ADDENDUM NO. 2

June 27, 2022

Additions and Renovations to Edgewood Intermediate School
7620 E Edgewood Ave.
Indianapolis, IN, 46239

Addendum Two (AD.02) to the drawings and specifications prepared by Gibraltar Design and The Skillman Corporation for **Edgewood Intermediate School Additions and Renovations** for Franklin Township Community School Corporation, Indianapolis, Indiana.

1. Sheet S-001

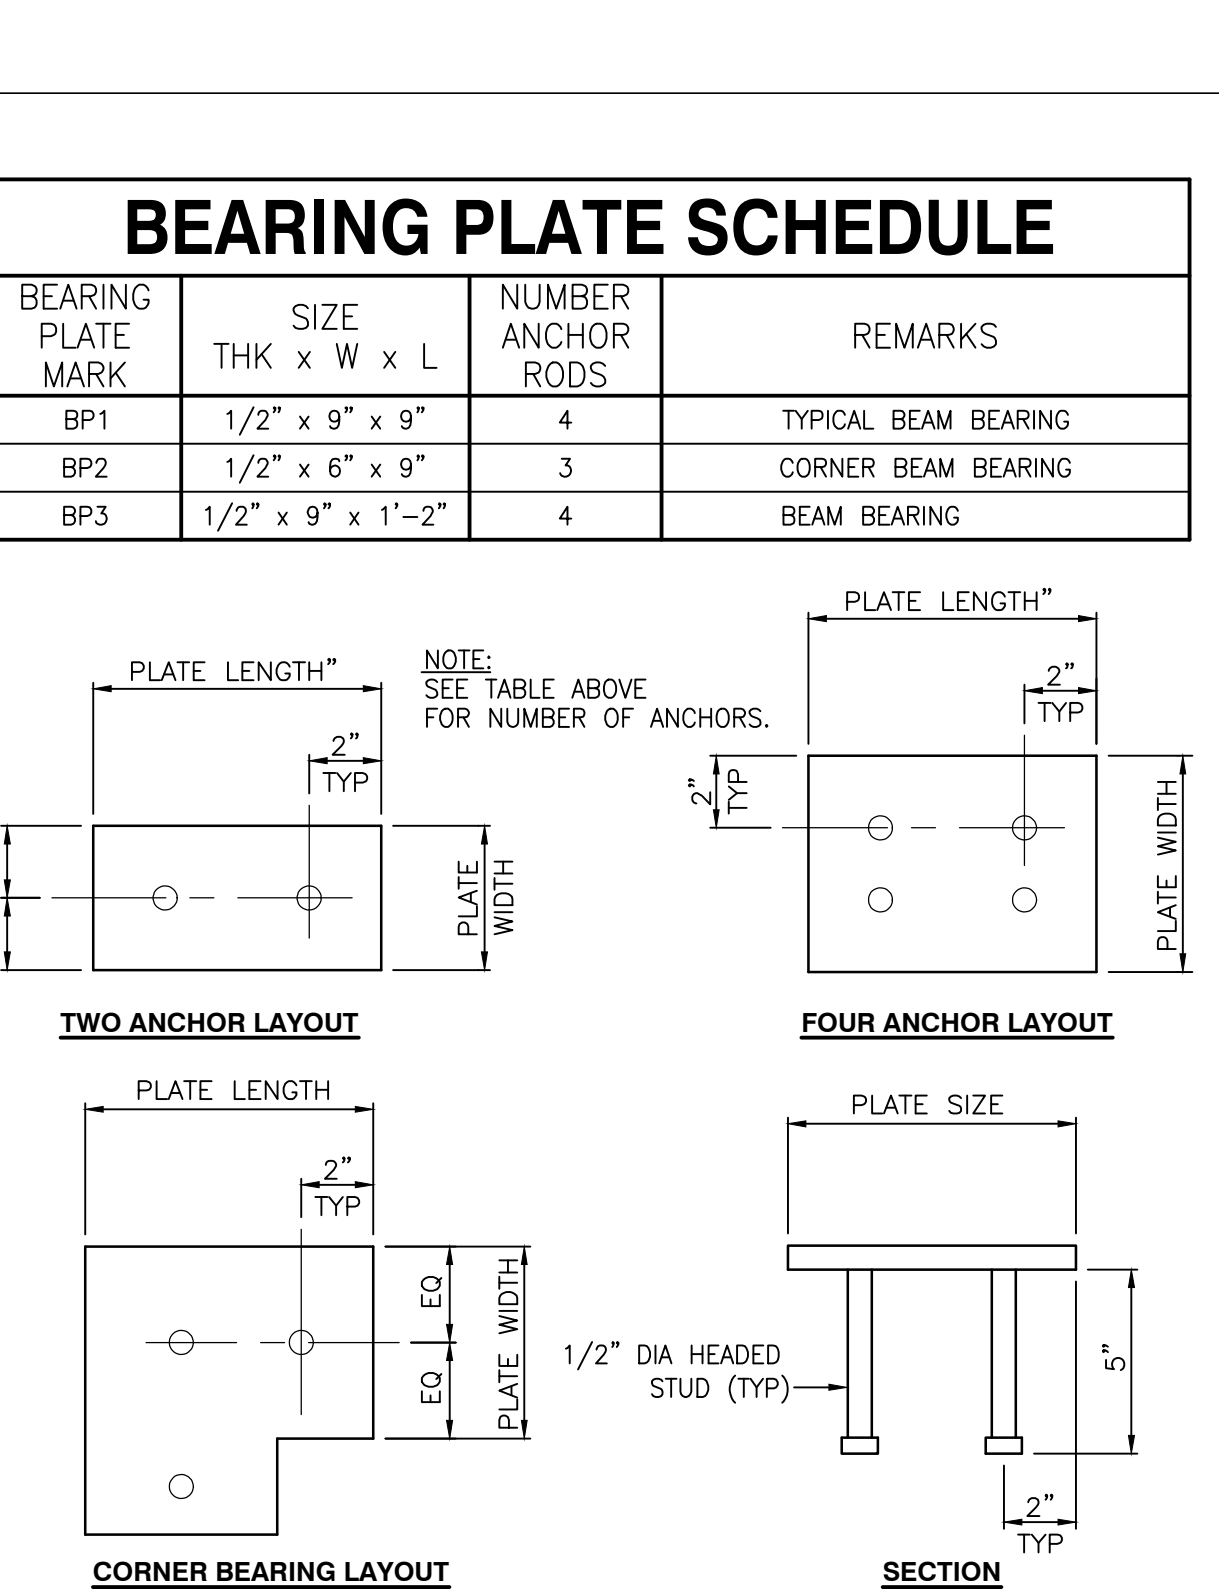
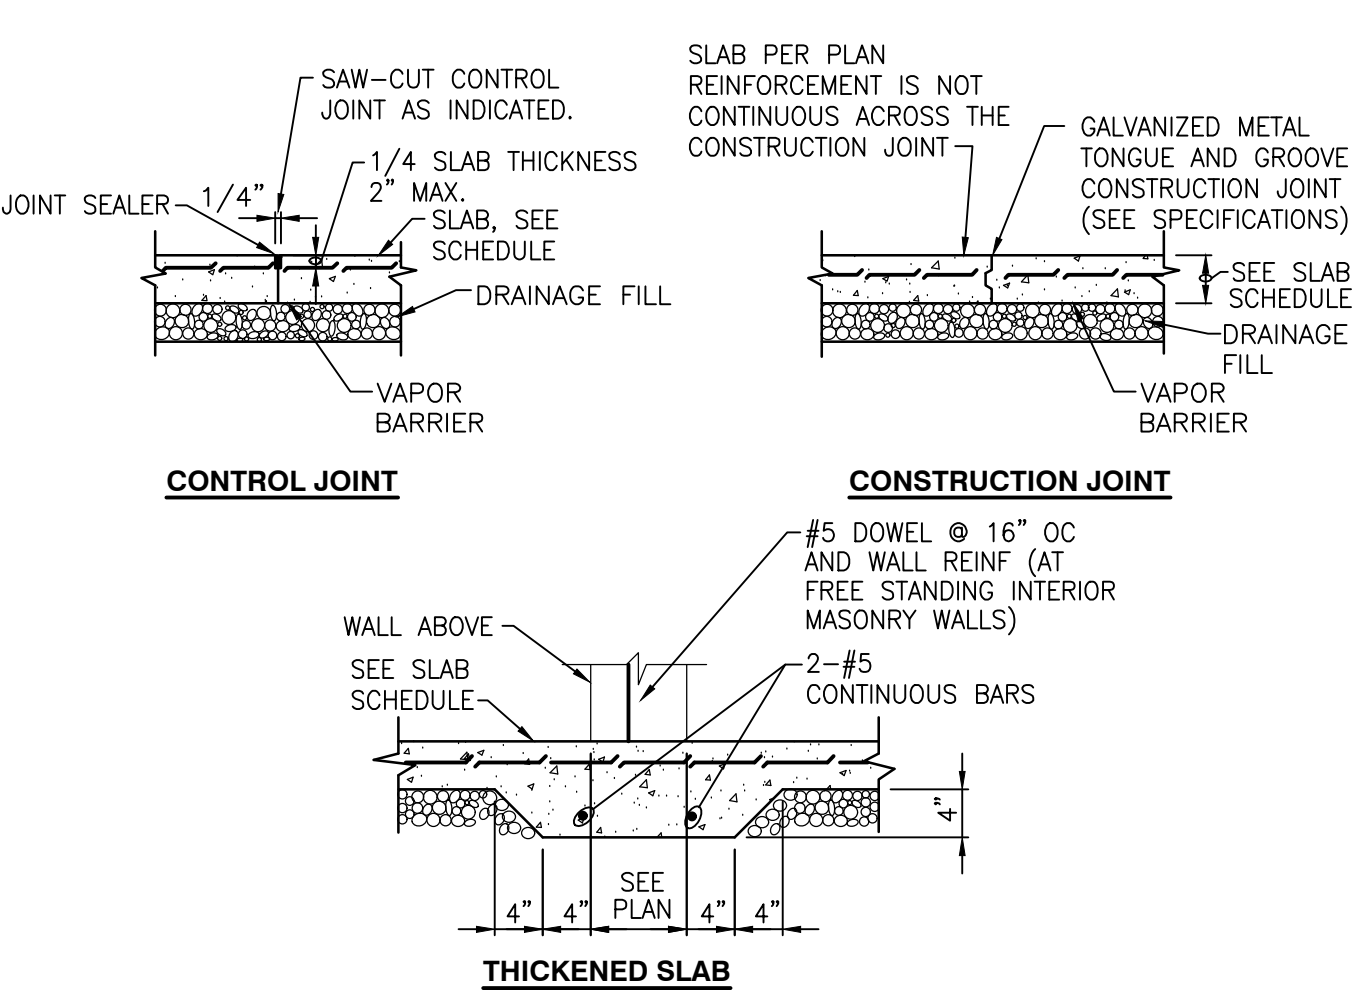
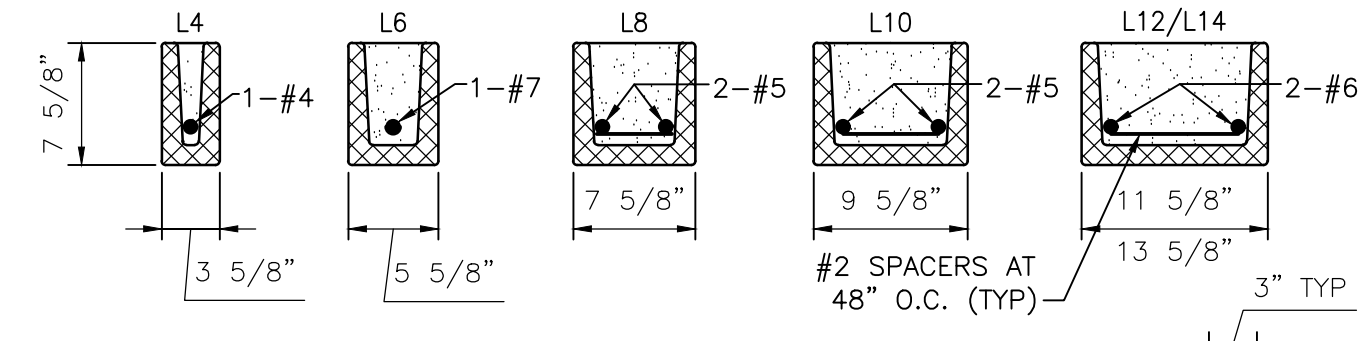
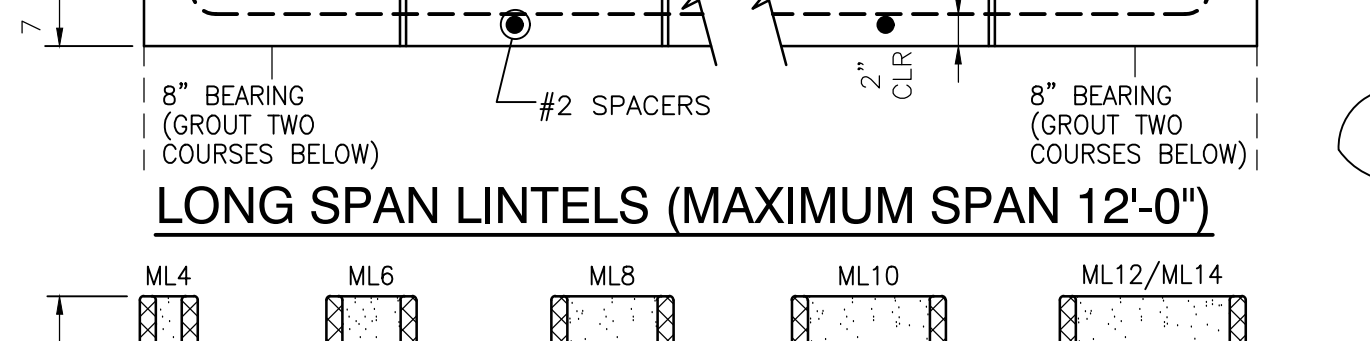
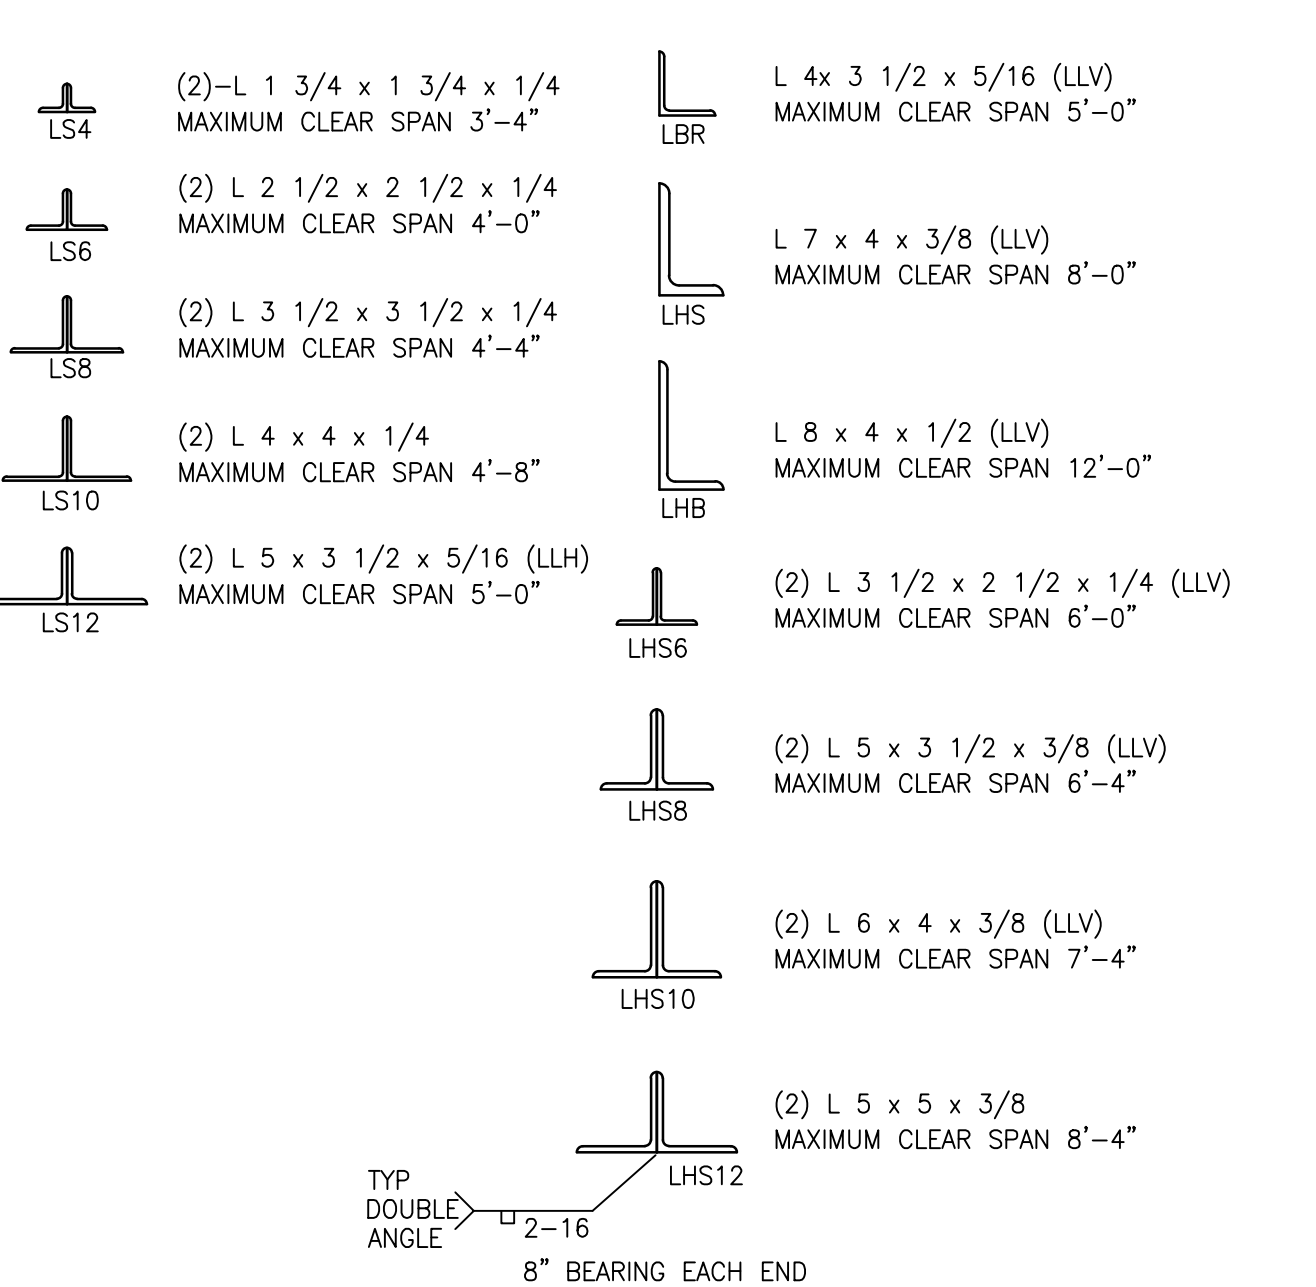
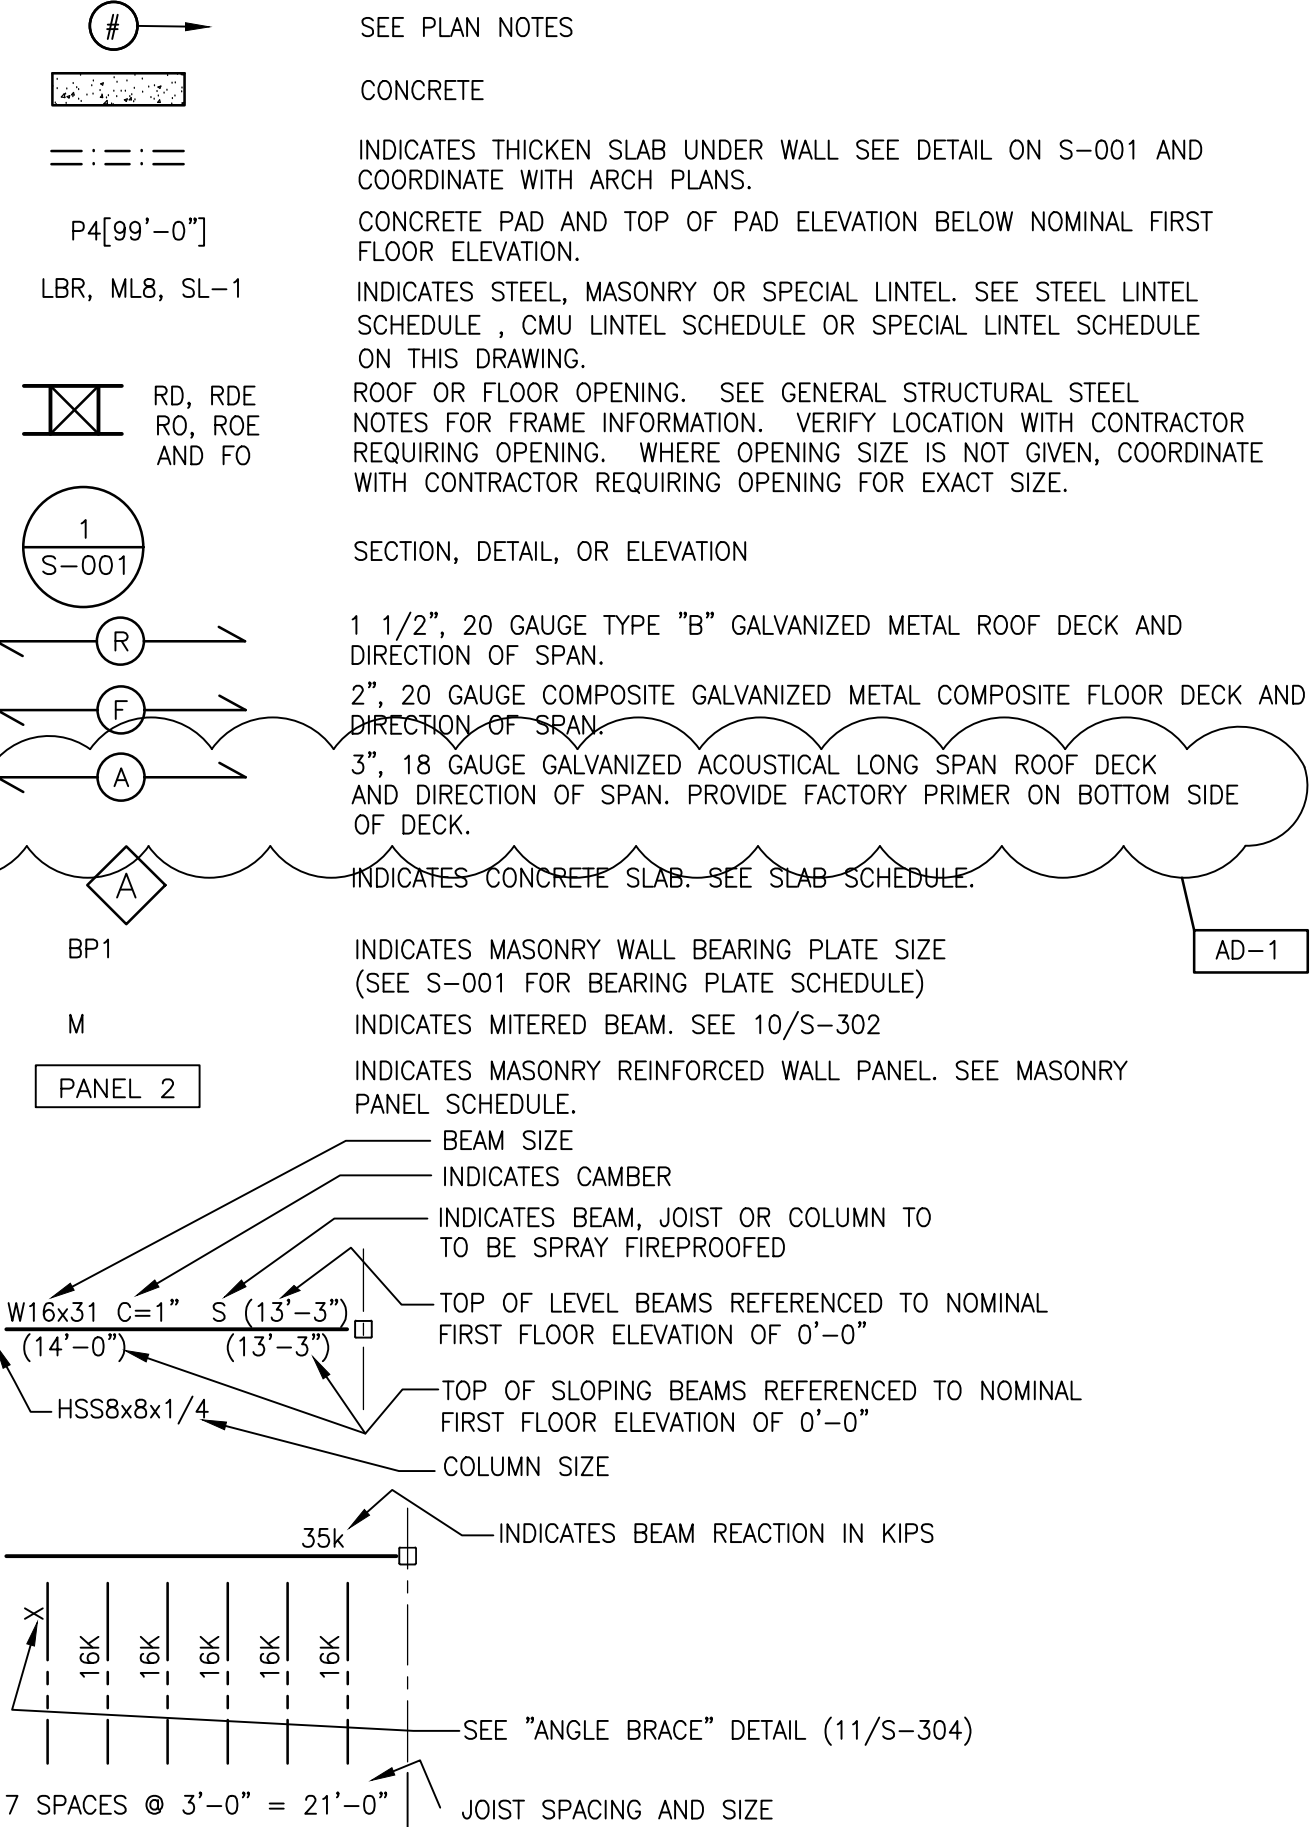
- A. Refer to revised, full-size drawing, included in this Addendum, for revised information in "Slab Schedule" for "B" slab type.
